YANKEE ATOMIC ELECTRIC COMPANY

2.C.2.1
FYR 81-73

Subject: Additional Information for SEP Topic IV-7.B, ESF Switchover

Reference (b) requested additional information for your evaluation of SEP Topic VI-7.B, ESF Switchover from Injection to Recirculation Modes at Yankee Rowe. The attachment has been prepared in response to your six questions.

SAFETY CLASS		SCALE	DRAWN BY
NONE			01K
TITLE		APPROVED BY	
PURIFICATION & V.C. RECIRC SYS		11/18/76	
DATE	DRAWING NUMBER		
3/4/76	M-16

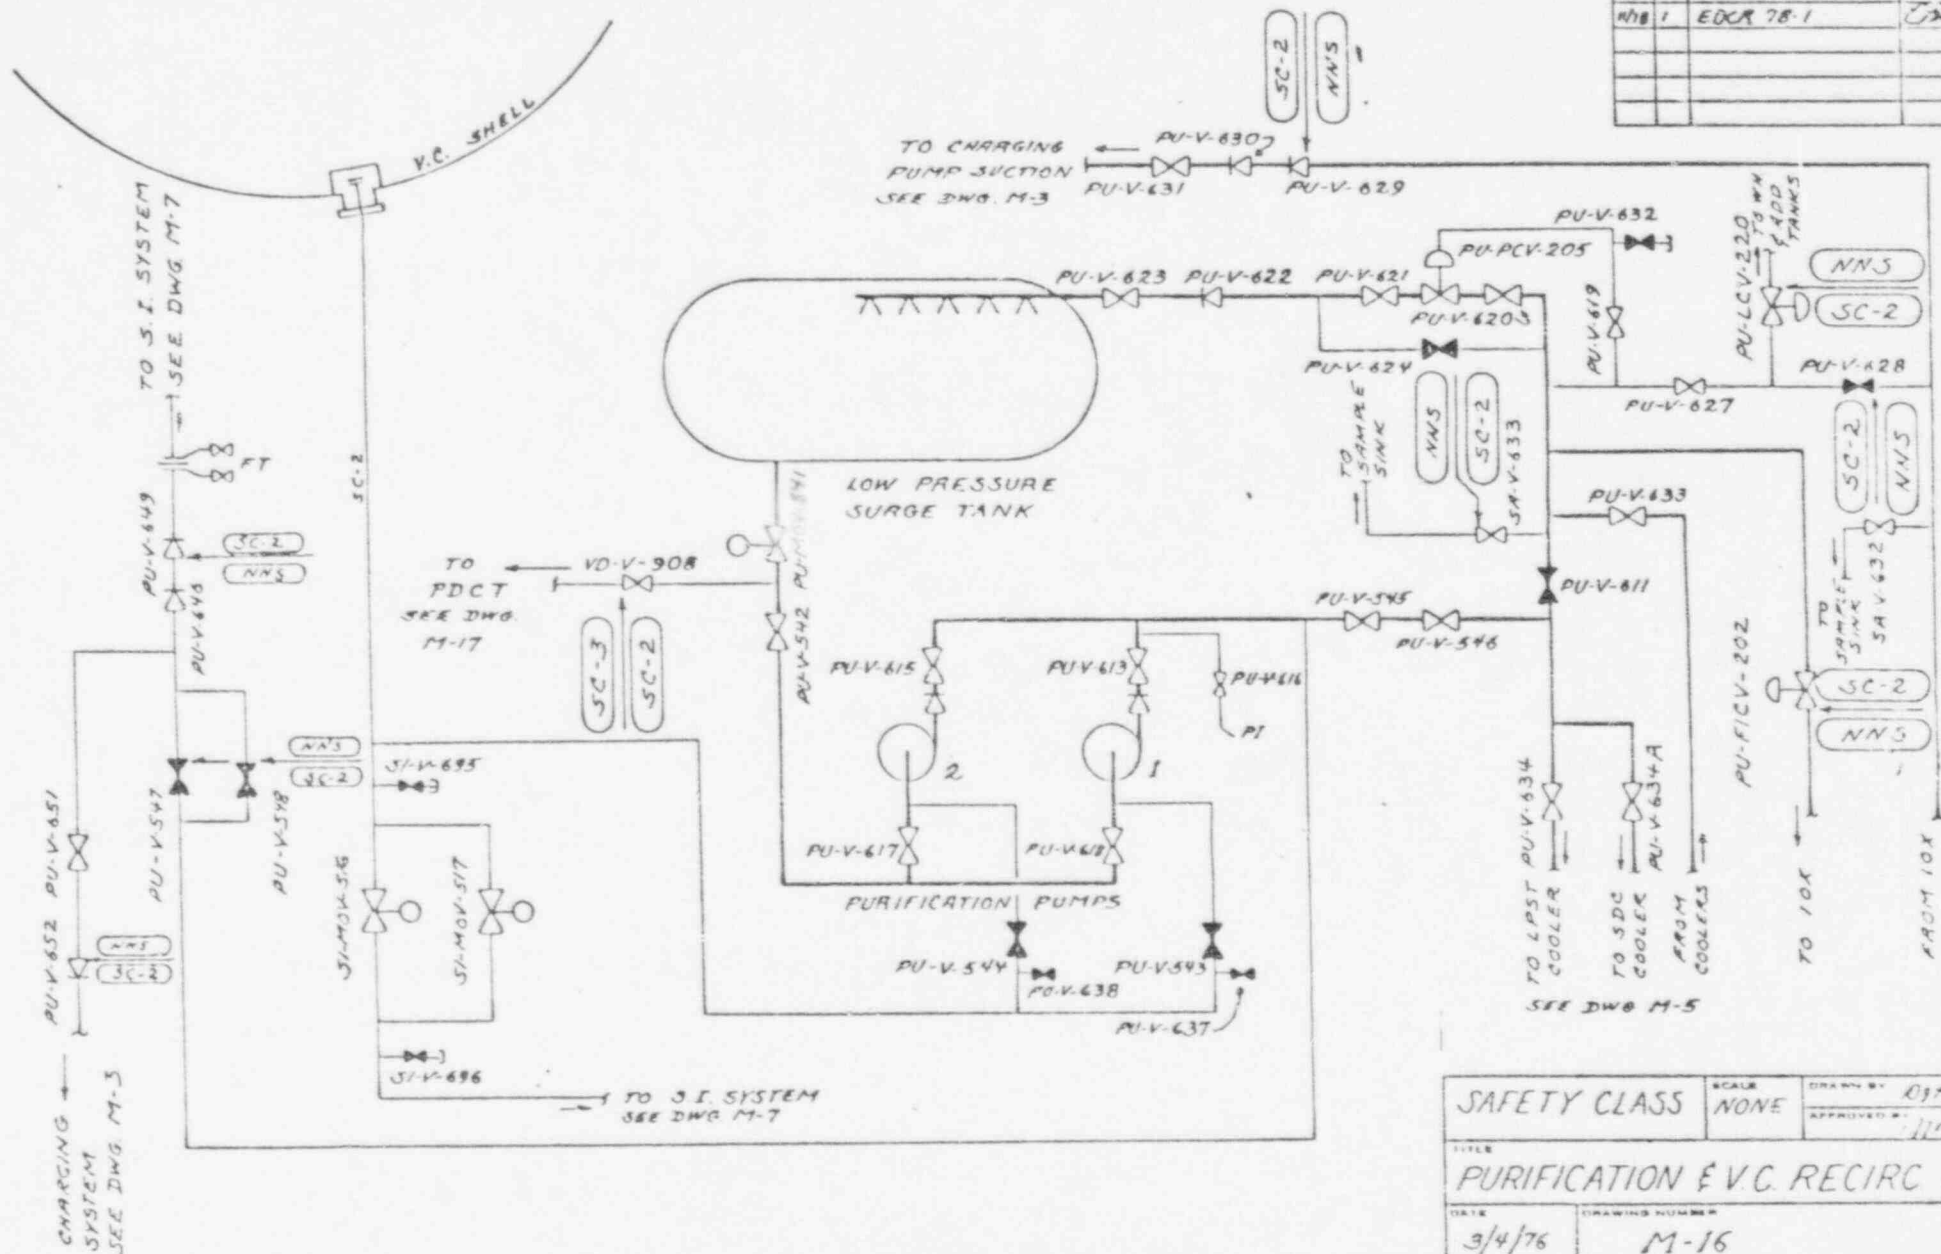
Question (1) Describe the procedures used to switchover from the injection to the recirculation mode of emergency core cooling (ECC).

The recirculation mode of emergency core cooling is initiated when the safety injection tank level reaches 11 feet. The operator performs the following actions:

- a. Close the LPSI header isolation valves, CS-MOV-533 and CS-MOV-535 (two valves in series).
- b. Close the HPSI pump recirculation valves, SI-MOV-48 and SI-MOV-49 (two valves in series).
- c. Open the vapor container sump suction valves, SI-MOV-516 and SI-MOV-517 (two valves in parallel).
- d. Close the suction valve from the safety injection tank, SI-MOV-518.
- e. If the vapor container pressure is unknown, or ≤ 10 psig, secure all but one LPSI and one HPSI pump.
- f. After recirculation flow is established, flow may be throttled with the HPSI header isolation valve, SI-MOV-46, as required for cooldown.

Copies of safety class drawings No. M-7 and M-16 are attached to assist in following this procedure.

TOLERANCES (EXCEPT AS NOTED)	YANKATE ATOMIC ELECTRIC CO.		
DRAWN BY	SCALE	DATE	APPROVED BY
±			WV
FRACTIONAL	TITLE EMERGENCY MCC NO. 2		
±	480 VAC		
ANALOG	DRAWING NUMBER		
±	E-4

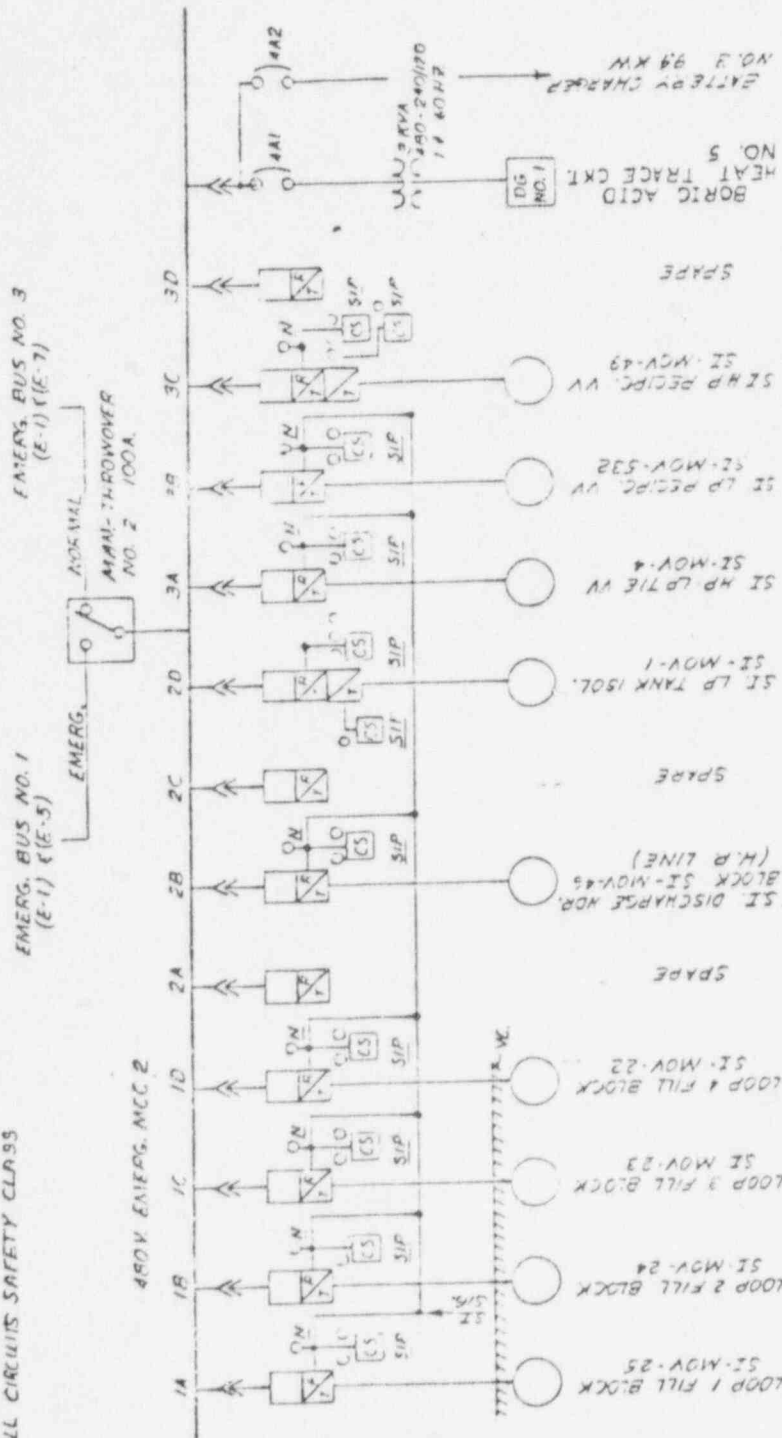
Question (5) Describe the paths of the minimum flow lines from each ECCS pump discharge to the line end. This description should identify all valves in these lines, the signals that control each valve, the power sources for each valve, and the qualification of each valve.

The two motor operated valves, SI-MOV-48 and SI-MOV-49, are manually controlled from the control room. Each motor operated valve is operated by a control switch and a key operated switch in series.

The power source for one of the motor operated valves is from the emergency MCC-2 located in the Safety Injection Building and the other is powered from MCC-4 Bus 2 located in the Primary Auxiliary Building. The Emergency MCC-2 is normally supplied power from the 5-2 bus and in an emergency is supplied power from the #3 diesel generator. MCC-4 Bus 2 is normally supplied from the 4-1 bus and in an emergency is supplied power from the #2 diesel generator.

Safety class drawings No. E-1, E-4, and E-5 are attached to allow following these power supplies.
